To: City Engineering Division, Department of Public Works Survey Bureau (Through Channels)
Subject: **NOTICE OF PROPOSED CHANGE IN PROPERTY PETITION X126**
From: Sergeant, Sherley Bledsoe Twelfth Precinct

This proposed change to outright vacate part of the east/west public alley, 16ft.WD in the block bound by Schafer Highway, Outer Dr., Hartwell Avenue and Santa Maria Avenue abutting lots 1, 2 and 6.

NOTICE OF PROPOSED CHANGE IN PROPERTY

A				REQUEST TO OUTRIGHT VACATE PART OF THE EAST/WEST PUBLIC ALLEY, 16 FT.WD IN THE BLOCK BOUND BY SCHAEFER HIGHWAY, OUTER DR., HARTWELL AVE. AND SANTA MARIA AVE. ABUTTING LOTS 1, 2 AND 6				CITY OF DETROIT CITY ENGINEERING DEPARTMENT SURVEY BUREAU			
DESCRIPTION		DESIGNED	CHECKED					APPROVED	DATE	JOB NO. 01-01	
DRAWN BY SA				CHECKED KSM							
DATE 03-11-19				APPROVED

PETITION NO. 126
 THE JOSEPH DEDVUKAJ FIRM, P.C.,
 177 WEST SQUARE LAKE ROAD
 BLOOMFIELD HILLS, MI., 48302
 PHONE NO. (248) 352-2110

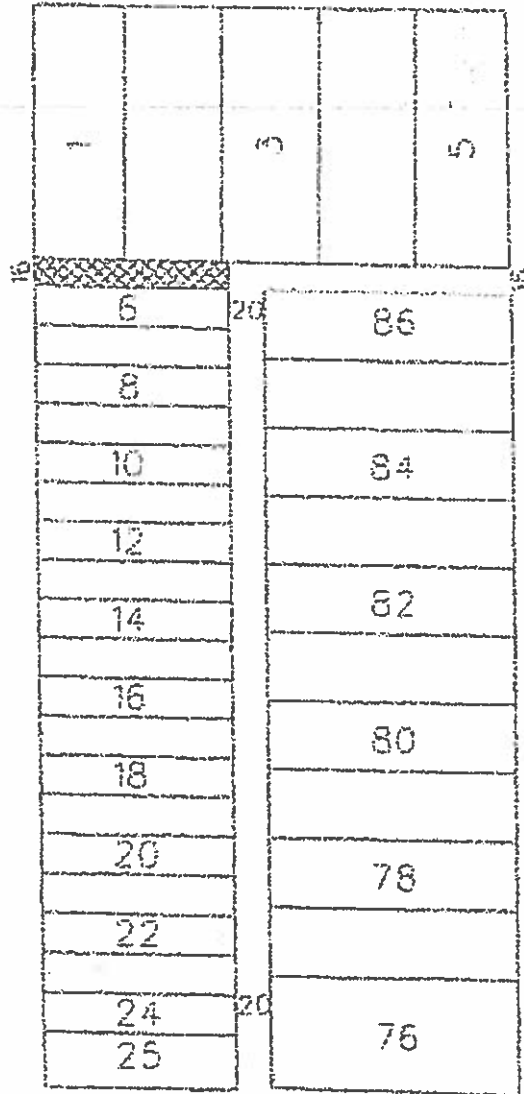
To vacate this area would be to block half of the alley I and the emergency vehicles would not have access to the area if needed. Currently this location allows for emergency vehicles to have access from Hartwell Avenue through to Schafer Highway. Vacating /Closing off this area would cause hardship for emergency vehicles.

* I CONCUR WITH SERGEANT BLEDSOE'S OBJECTION TO THIS PROPERTY CHANGE.

On May 28, 2019 I spoke with the City Engineering Division and received the understanding that this proposed change will not block off the alley. Therefore with this new information, the Detroit Police Department is involved, but no objection to the property change.
